101 072 208 REV.

118 302 289-D

ASSY ST. SW. CONTROL BD. EA

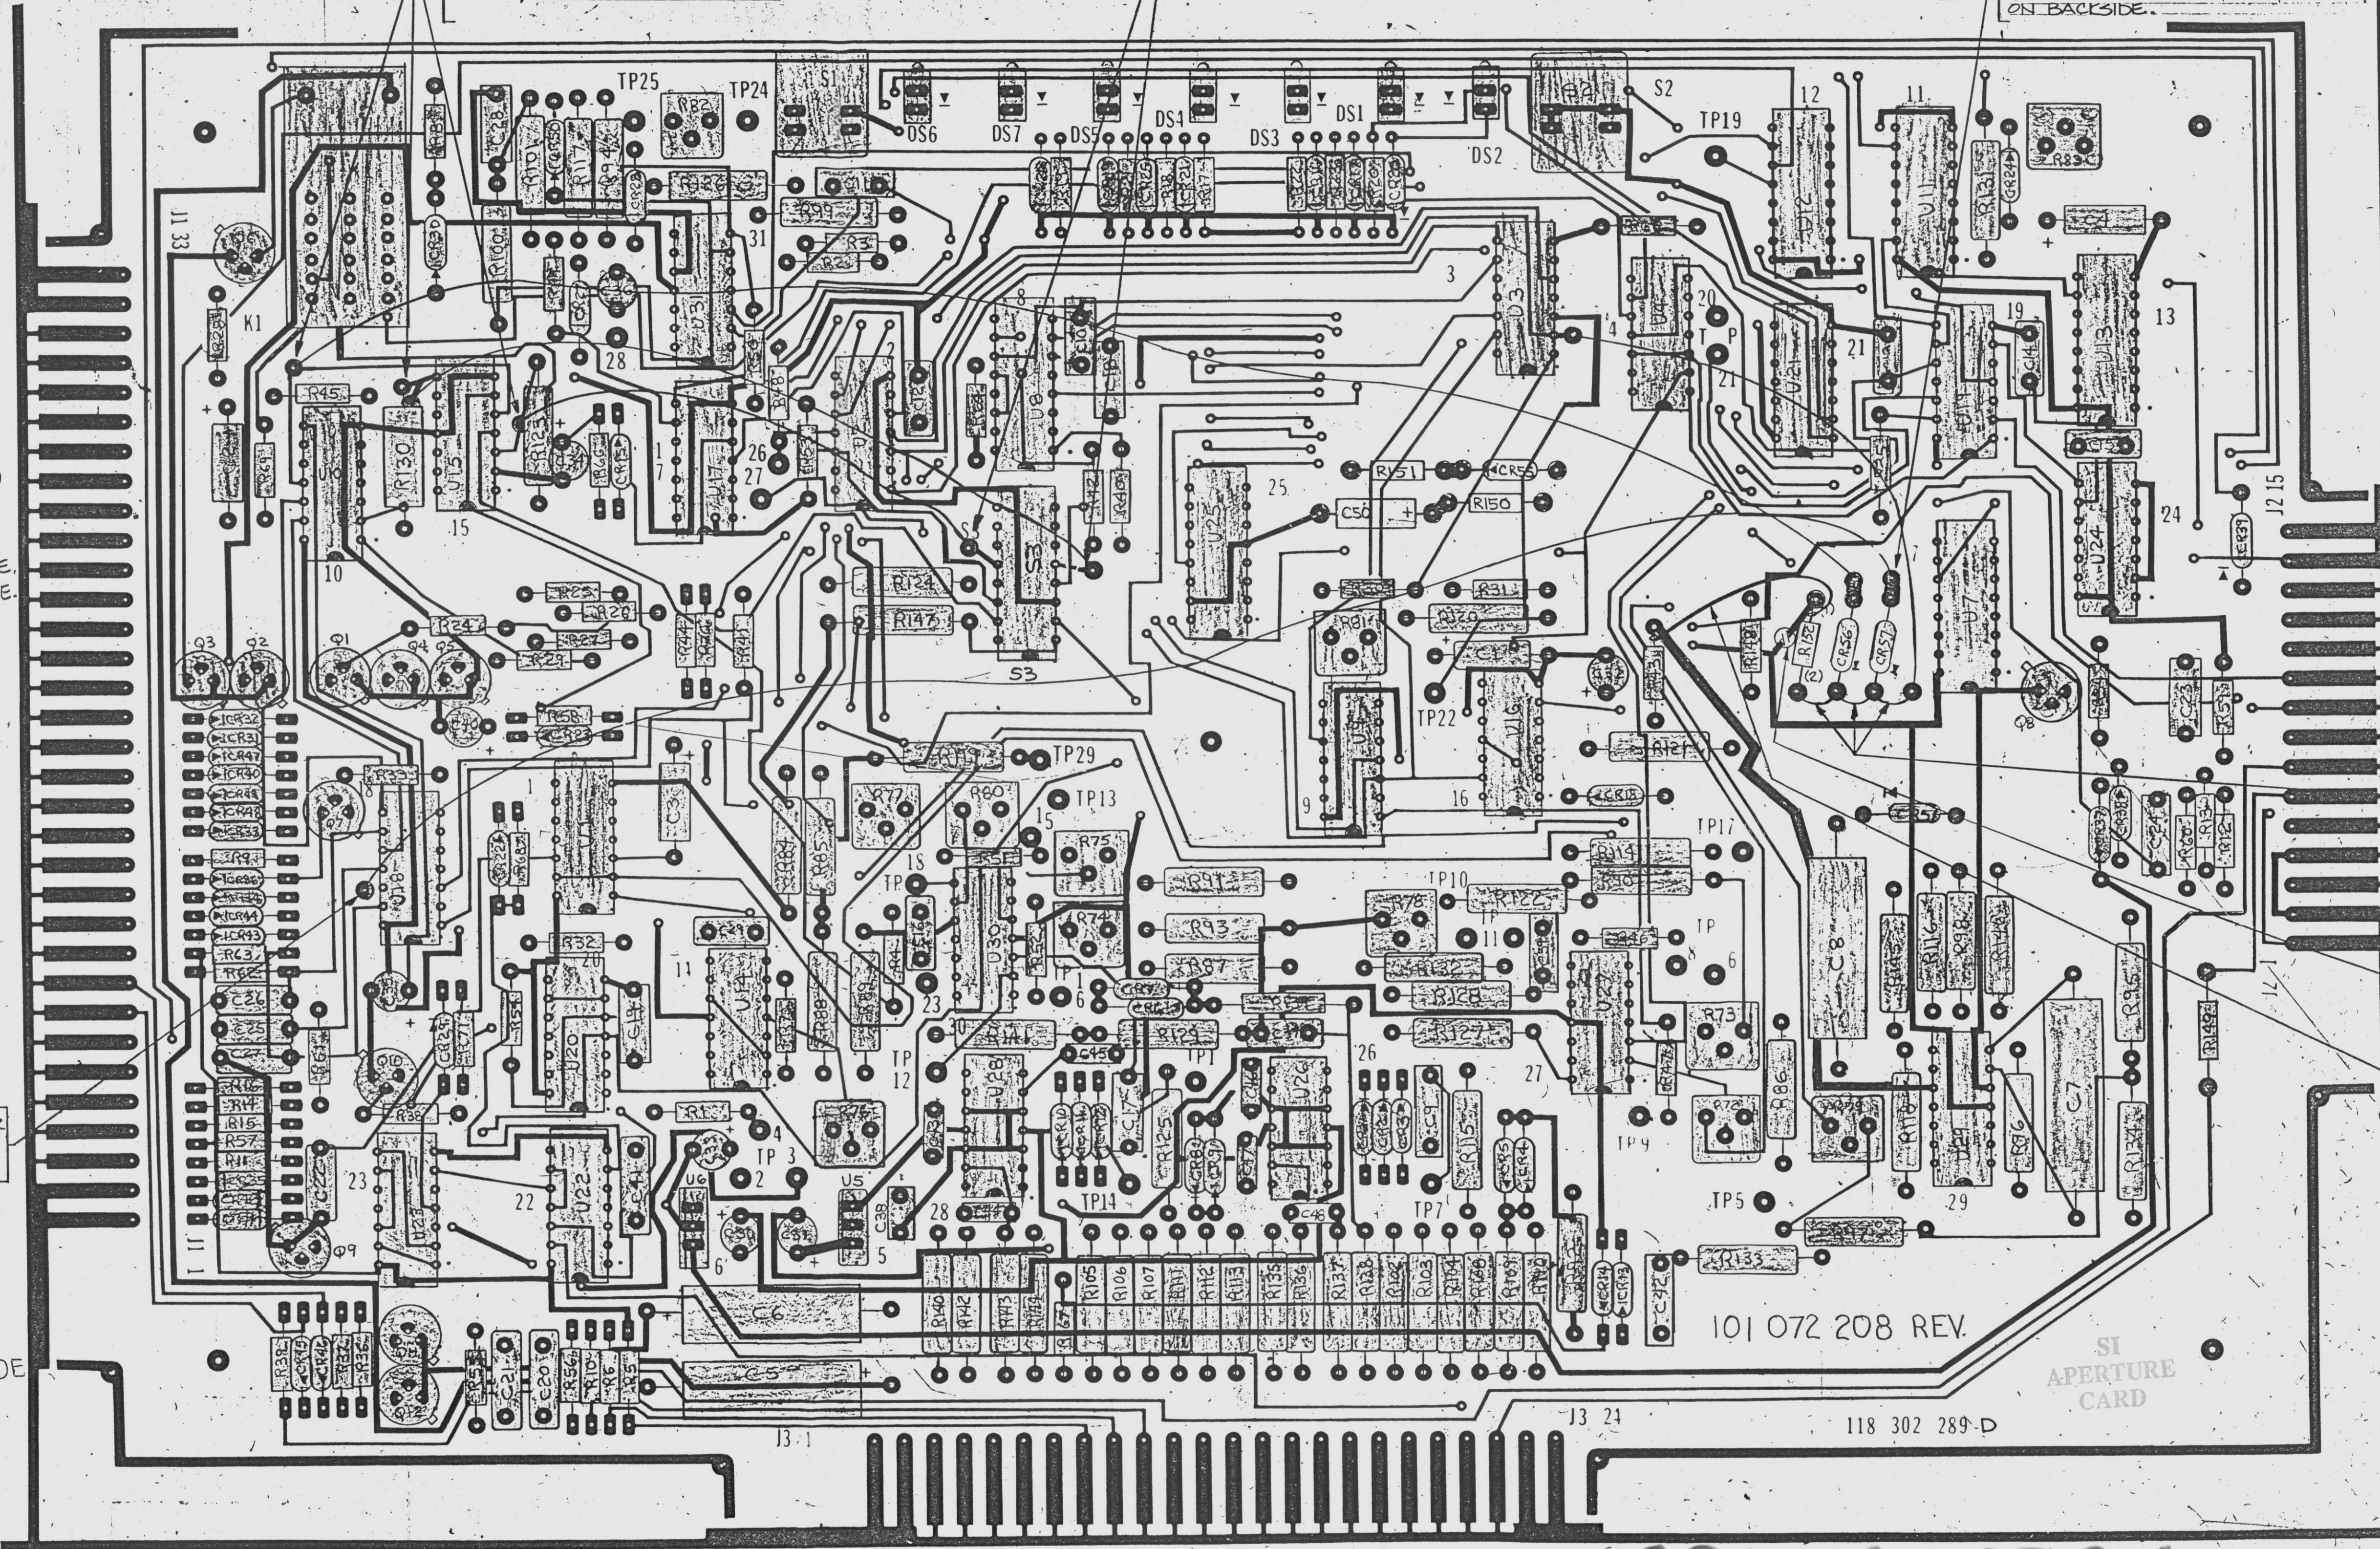
IF BOARD IS 118 302 289 REV. C; FOLLOW INSTRUCTIONS TO ADD R152, CR56, & CR57 AND ALL JUMPERS BY DRILLING HOLES TO MOUNT COMPONENTS & JUMPERS.

IF BOARD IS 118 302 289 REV. B; VERIFY/PERFORM CN6073-1 & MODIFY TO 101 072 208-D1 CONFIGURATION (ADDED R150, R151, C50, & CR55) BEFORE ADDING R152, CR56, CR57, & JUMPERS.

1. CUT DIRECT RUN ON BACK BETWEEN U15-5 & U2-4.
2. DRILL HOLES TO MOUNT PARTS R151, CR56, & CR57.
3. ADD JUMPER FROM R152-1 TO R43 GND FOR 118 302 289 REV. B, C, & D;
4. ADD JUMPER *: a) 53-5 TO U15 PIN 8 RUN.
b) 53-12 TO U15 PIN 3 RUN.
(SOLDER TO R123 UNTIL REV. D BOARD AVAILABLE)
- c) U2-4, U3-2 TO JUNCTION OF CR60 CATHODE & CR57 CATHODE, & R152-1.
- d) U15-5, U10-11 TO CR56 ANODE.
- e) U18-12, U15-6 TO CR57 ANODE.

* ROUTE JUMPERS THE NEATEST WAY, NOT AS SHOWN ON ASSY. FOR END LOCATION PURPOSES: JUMPERS TO BE #22 SOLID INSULATED WIRE.

DRILL HOLE & SOLDER JUMPER TO RUN (U18-12) ON BACKSIDE IF PAD IS NOT PRESENT.

DRILL HOLE & SOLDER TO RUN. PUT JUMPER THROUGH BOARD TO SOLDER ON BACKSIDE TO U15-8; IF PADS NOT PRESENT.

DRILL HOLES TO MOUNT JUMPERS THROUGH TO BACKSIDE & SOLDER TO 53-5 APPROX. AS SHOWN IF PADS NOT PRESENT.

IF ARTWORK REV. C OR BEFORE IF PADS NOT PRESENT DRILL HOLES TO MOUNT COMPONENTS AND TO SOLDER JUMPERS TO COMPONENTS ON BACKSIDE.

IF REV. C OR BEFORE ARTWORK, JUMPER TOGETHER R152, CR56, CR57 ON BACKSIDE AS SHOWN.

CUT RUN (U) (REV. D)

ADD JUMPER (U) REV. D
